P 515080

ON-SITE SEWAGE DISPOSAL SYSTEM HOWARD COUNTY HEALTH DEPARTMENT BUREAU OF ENVIRONMENTAL HEALTH

SUBDIVISION: Malcolm Property LOT NUMBER: 11

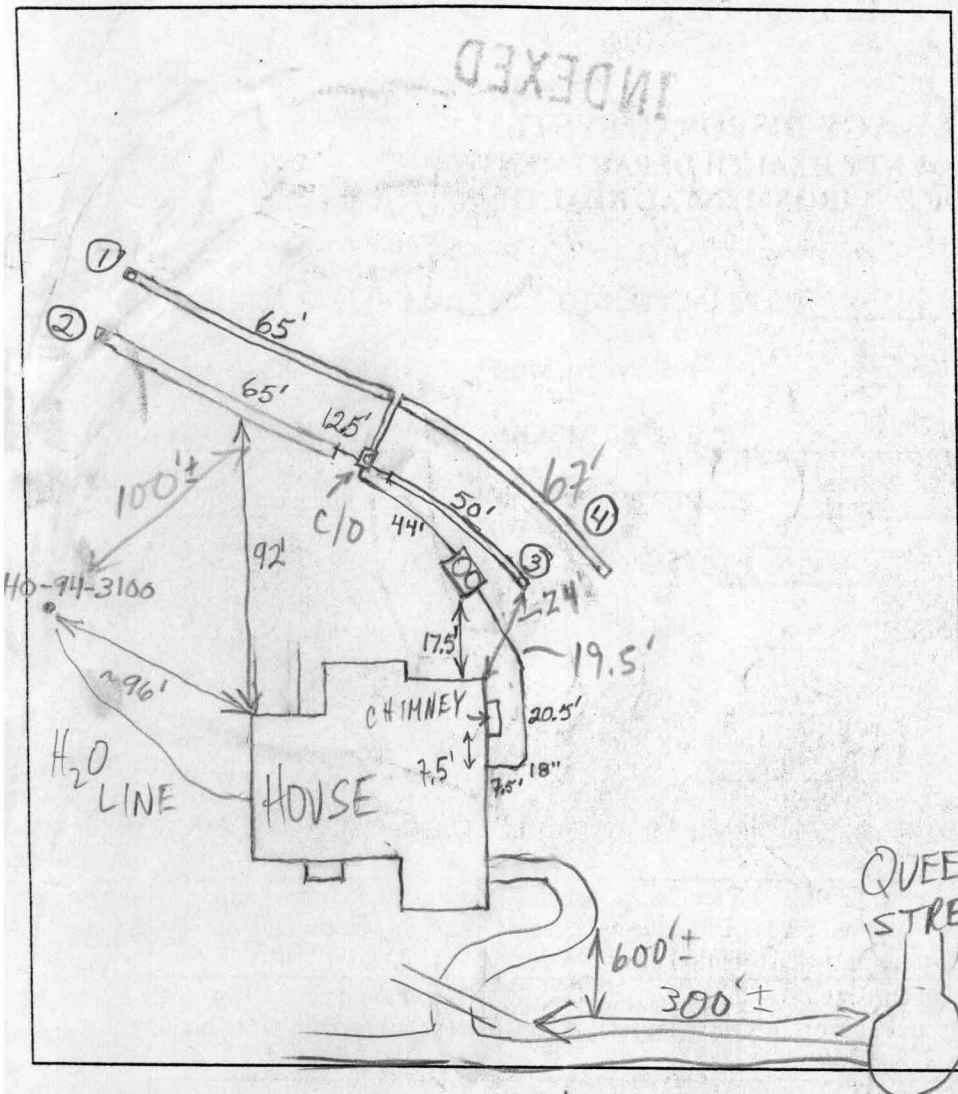
PRE-CONSTRUCTION INSPECTION: 8/13/01 Easement staked. To install as per B.P. plan. (BB)

INSPECTION COMMENTS: 8/13/01 No house connection. Trenches 1+2 are done. Trench 3 50% done. Cleanout on distribution box and at ends of trenches. O.K. to cover everything except start and end of trench 3 and 4. Installer asked if he could leave baffle out of distribution box so that he could clean lines easier - told him O.K. (BB)

8/14/01 OK TO COVER TRENCHES, HOLD FOR HOUSE CONN. (MR)

8/24/01 HOUSE CONN OK (MR)
